ADDENDUM #2
To BID #26017
TUSD School Fencing Project

December 24, 2025

RE: Addendum #2

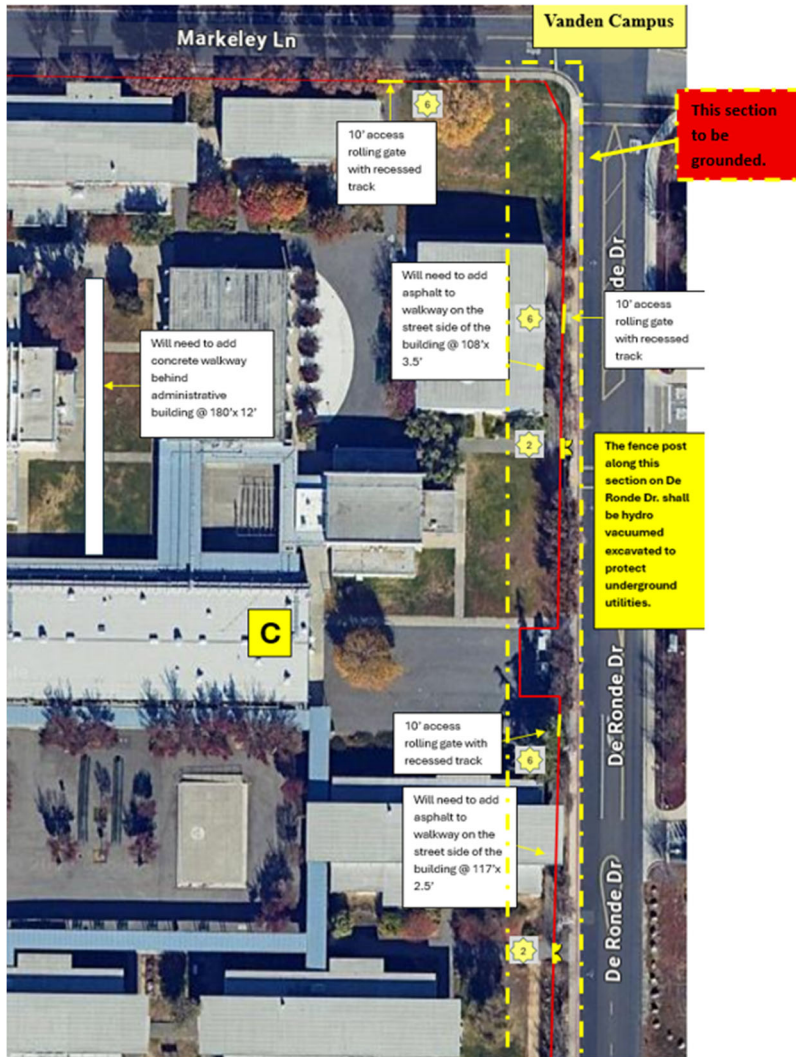
10. I noticed the spec calls for grounding and bonding of the fencing, Can the district remove the spec and or identify the exact qty and locations where this will be required?

6. Confirm if grounding is needed and a detail, and a quantity. Cadweld is needed for grounding?
 - **Answer – Grounding is needed around electrical equipment or underground utilities. The locations that are known to have high voltage underground utilities are indicated on the reference maps below. Intervals and locations shall follow the specifications in Project Scope 3.5, Grounding and Bonding.**
